## Service Bulletin

**Model:** D-121/125

**No. 376**

**Subject:** Optical Flexible Board Jamming Sled

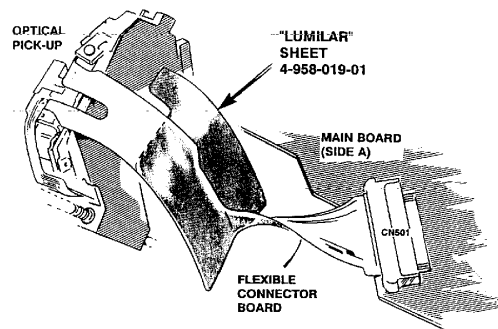
**Symptom:**  
(62)

The flex cable from the optical assembly gets jammed under the slide mechanism and prevents it from coming "home" to read TOC.

**Solution:** Attach a lumilar sheet to the optical flexible board as shown.

REF	DESCRIPTION	PART NUMBER
-	LUMILAR SHEET	4-956-818-01
